Building Manager: [Mohammad Azizian, mohammad.azizian@oregonstate.edu](mailto:mohammad.azizian@oregonstate.edu)
 Assessment Date: 5/4/2022
 Assessment Number: **10574**
 Location: Merryfield Hall Entire
 Reinspection date:

A joint fire safety inspection of the facility listed above was performed by the Environmental Health & Safety - Fire and Life Safety and the Corvallis Fire Department. These fire safety deficiencies could result in a fire or jeopardize the safety of those occupying the facility. Please see that these items are corrected immediately and no later than the scheduled reinspection date noted with this report. If you have any questions regarding this inspection, please email Brian Lilley (EH&S - Fire and Life Safety) at brian.lilley@oregonstate.edu.

Room 103A Blocked Exit Door

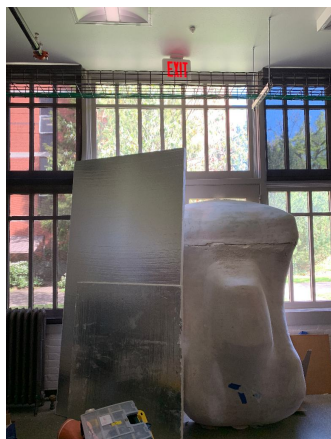
Priority code	Standard in need of attention	Reg.Reference	Location	Resp	Observations & Recommendations	Date Corrected
2	A means of egress shall be free from obstructions that would prevent its use. Combustible materials shall not be stored in exit pathways.	2019 OFC 1031.3 and 315.3.2	0103A:exit	DEPT	Remove items from exit door and do not block.

Room 117

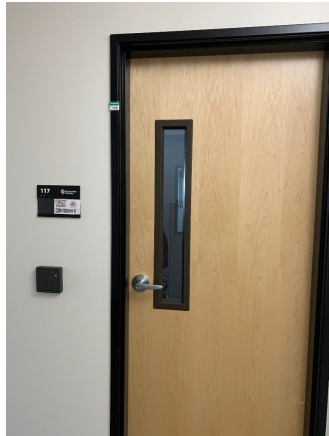
2	All sprinkler valves shall be supervised/locked in the open position, accessible, and unobstructed. Door to control room shall be identified.	2019 OFC 901.4.6.1 and 903.3.8.4	117:entrance	FS	Provide fire sprinkler riser room sign for door.	
---	---	----------------------------------	--------------	----	--	--
